KBSO Project #: 24023
Project Name: Noblesville HS AHU Replacements – Bid Pack 2
Issue Date: 10/10/2024

This Addendum number 1 to the drawings and specifications shall supplement, amend, and become a part of the bidding documents, plans, and specifications. All bids and construction contracts shall be based on these modifications to the original contract documents.

**MECH RM M11
MECHANICAL
DEMOLITION
PLAN**

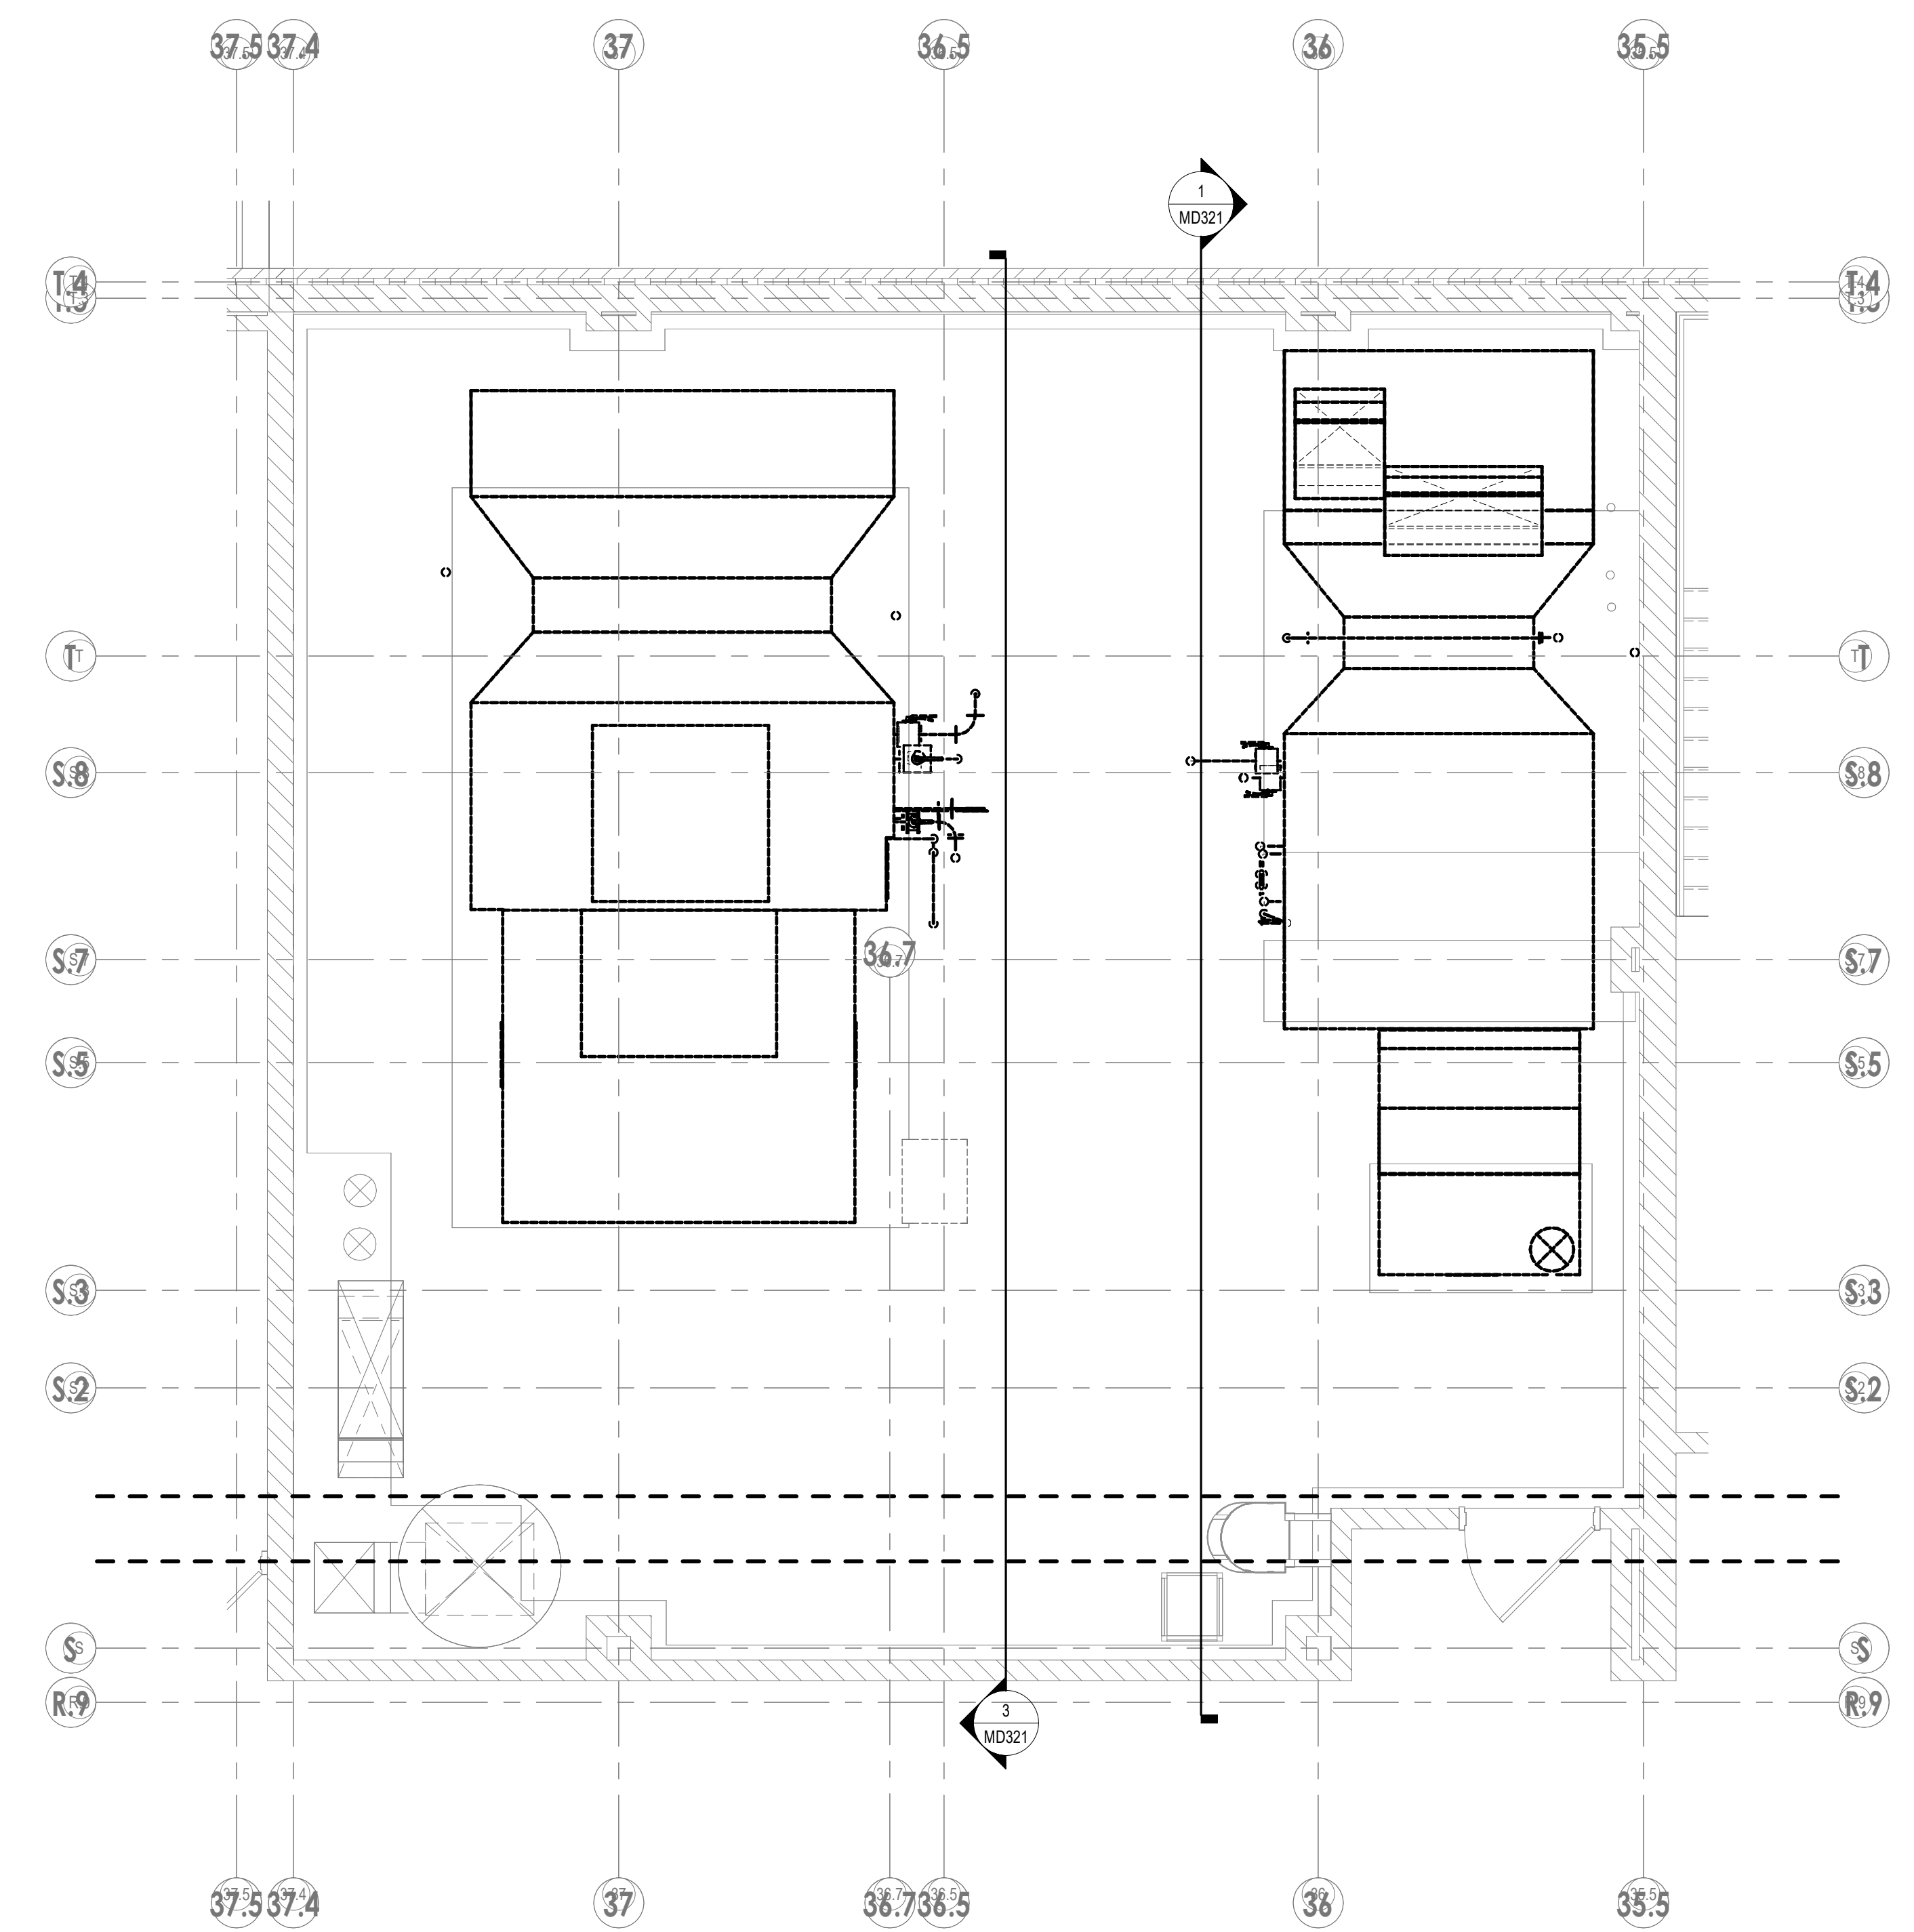
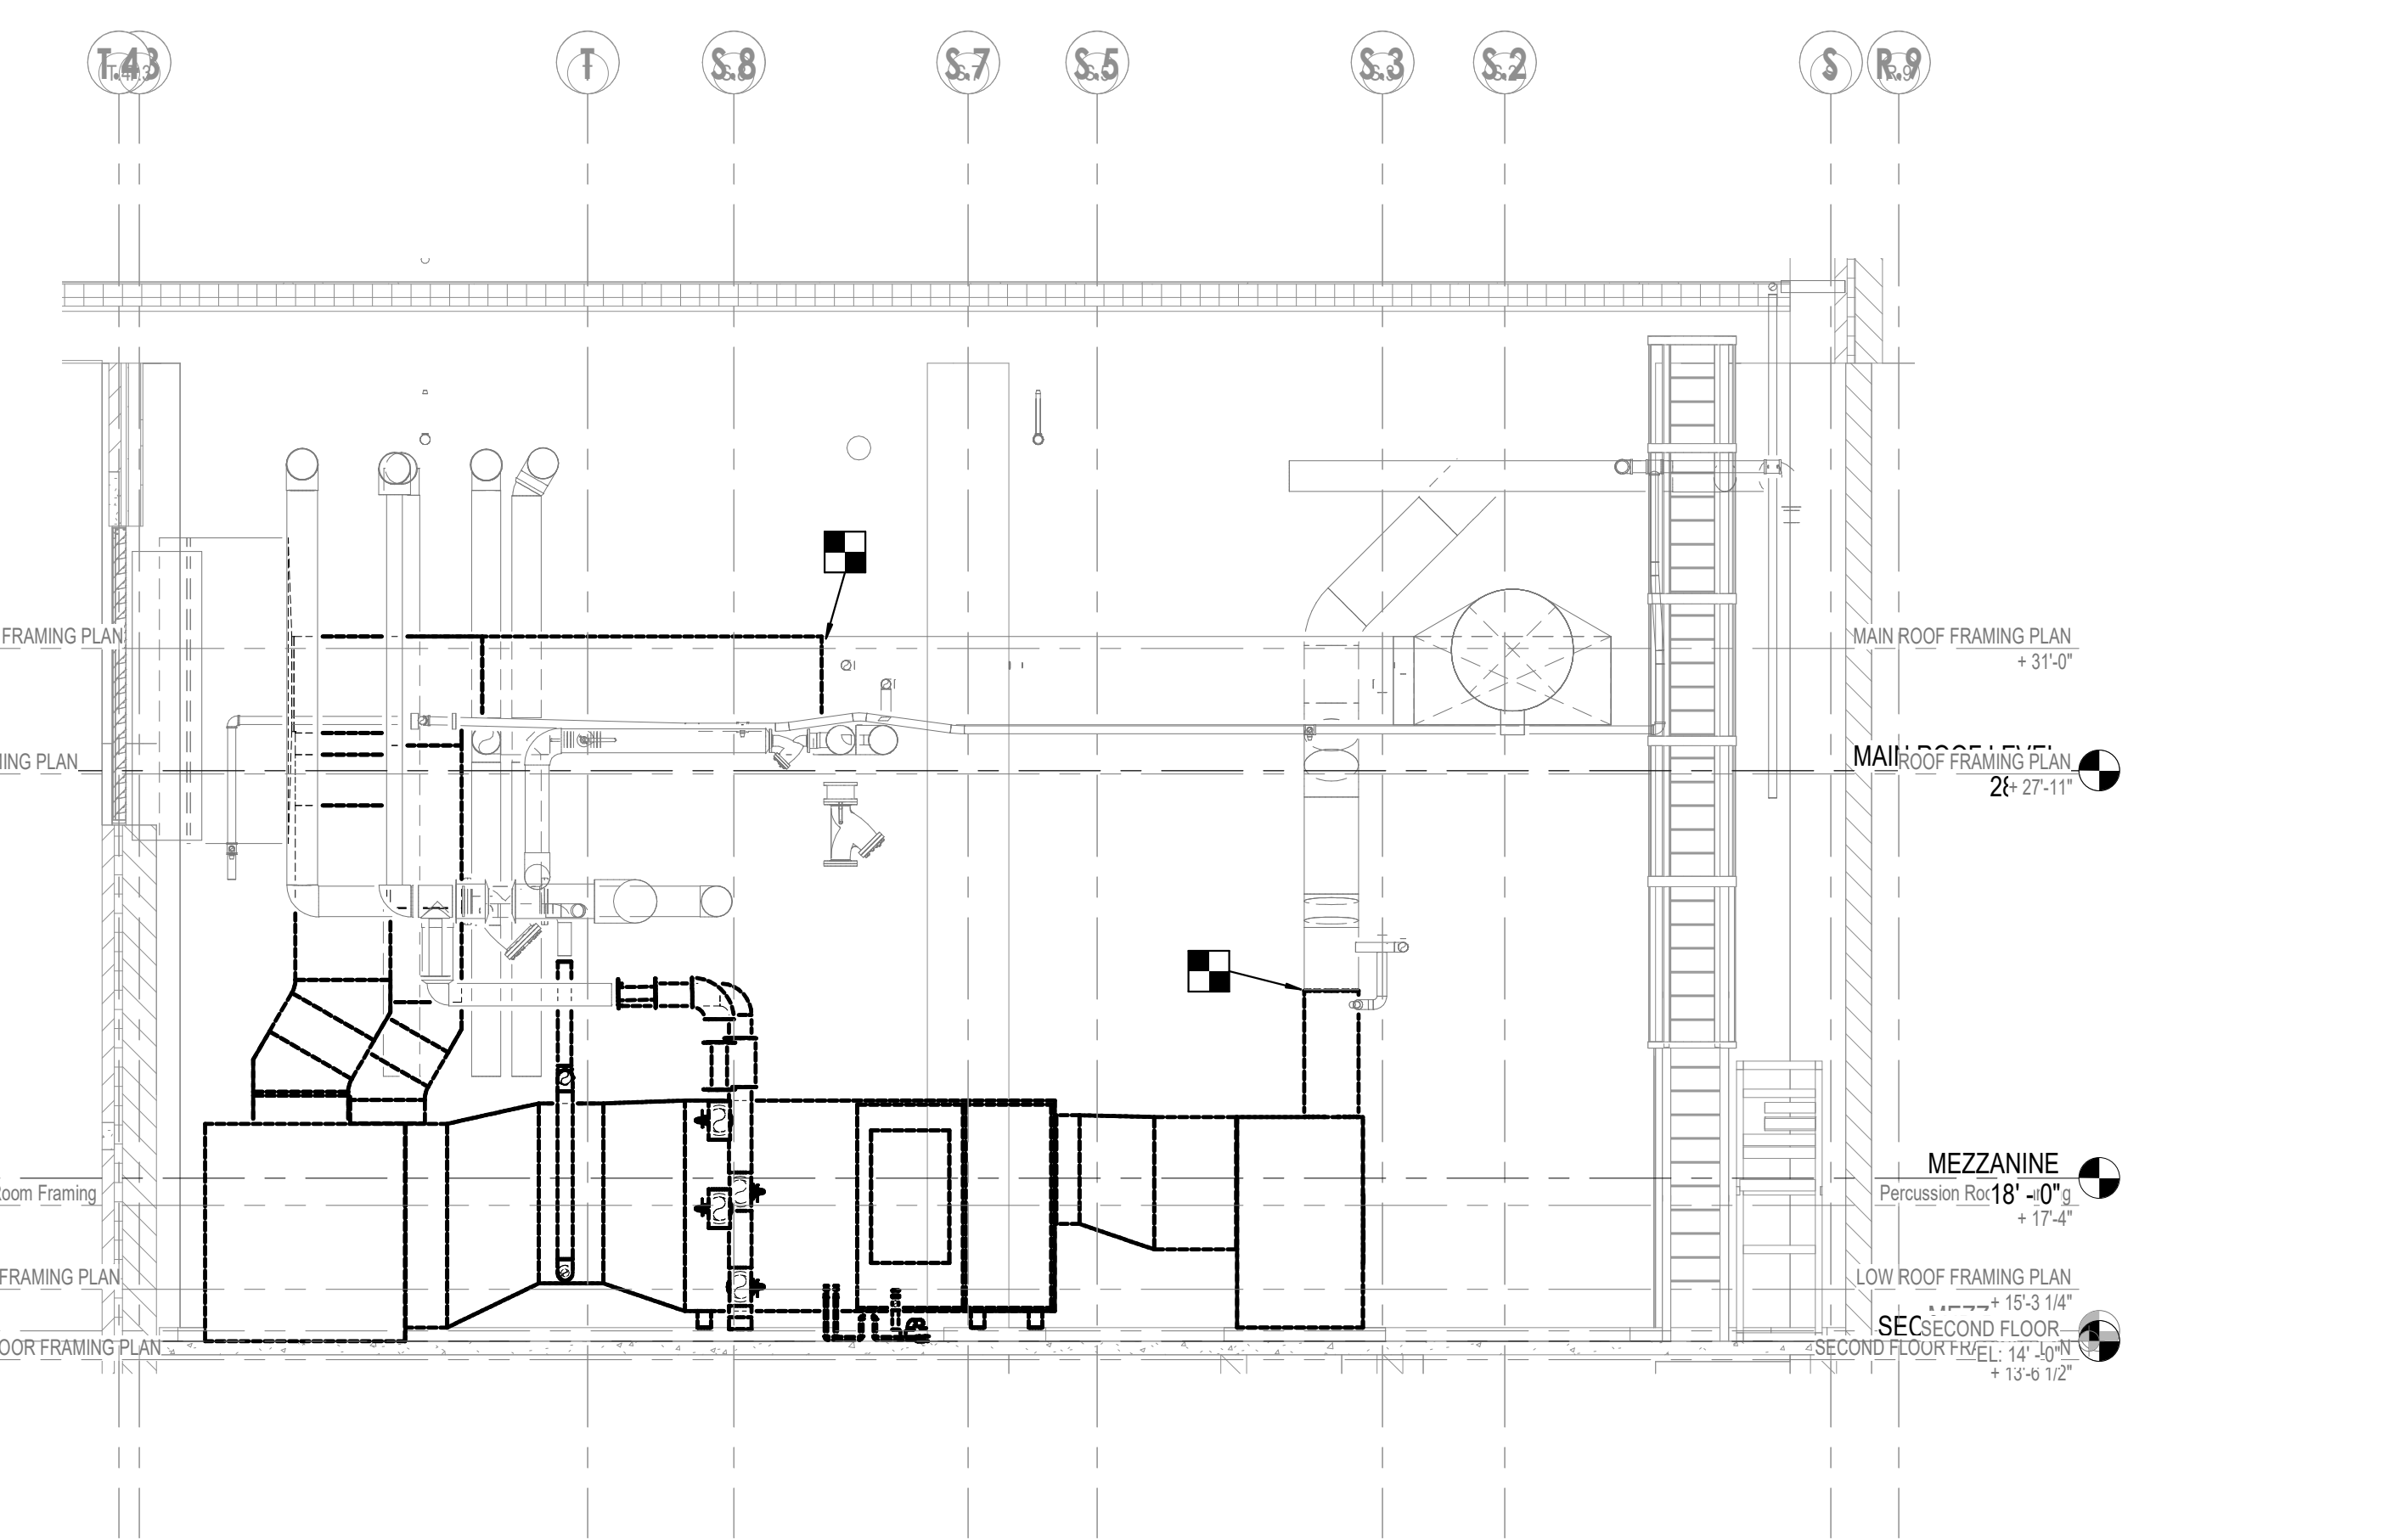
- 3.01 M521 - MECHANICAL DETAILS
 - a. See revised drawings with revision clouds included
- 3.02 M621 - MECHANICAL SCHEDULES
 - a. See revised drawings with revision clouds included
- 3.03 M721 - GROUND FLOOR CONTROLS & LOGISTICS PLAN
 - a. See revised drawings with revision clouds included
- 3.04 M722 - SECOND FLOOR CONTROLS & LOGISTICS PLAN
 - a. See revised drawings with revision clouds included
- 3.05 MD321 - MECH RM M11 MECHANICAL DEMOLITION PLAN
 - a. See revised drawings with revision clouds included
- 3.06 MD322 - MECH RM M12 MECHANICAL DEMOLITION PLAN
 - a. See revised drawings with revision clouds included

- 1 REMOVE FIRE DAMPER
